DEVELOPMENT REVIEW COMMITTEE (DRC) COMMENT REPORT

PROJECT NAME: Joseph C. Carter Park

CASE NUMBER: UDP-S23047

REQUEST: Site Plan Level II Review: 26,640 Square Foot

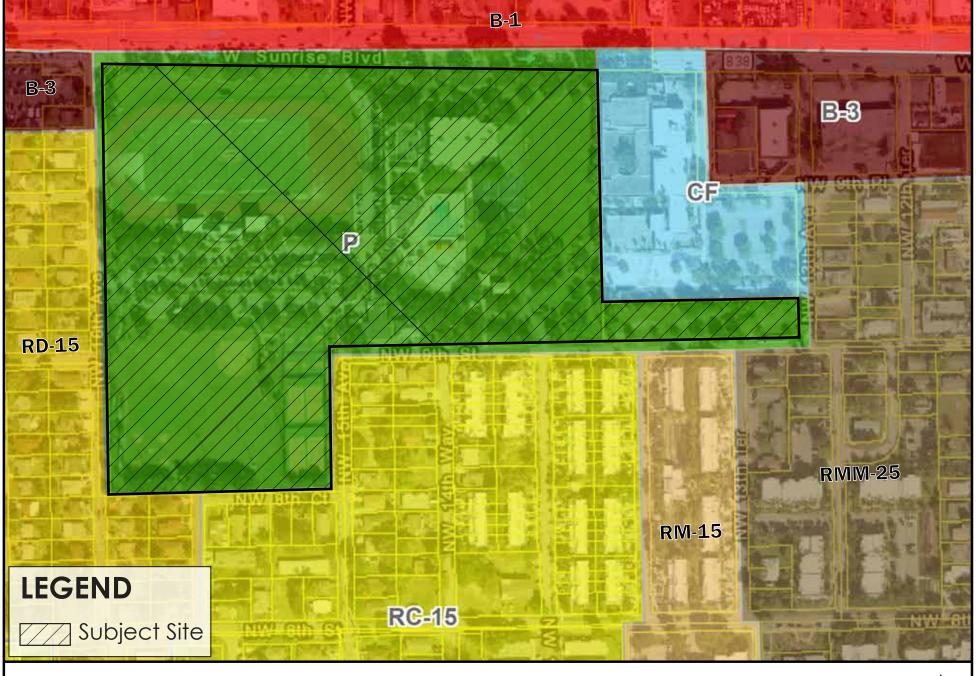
- a. Provide an overall illustrative site plan that clearly depicts the property with the site boundaries, setbacks, and proposed changes. See example image below.
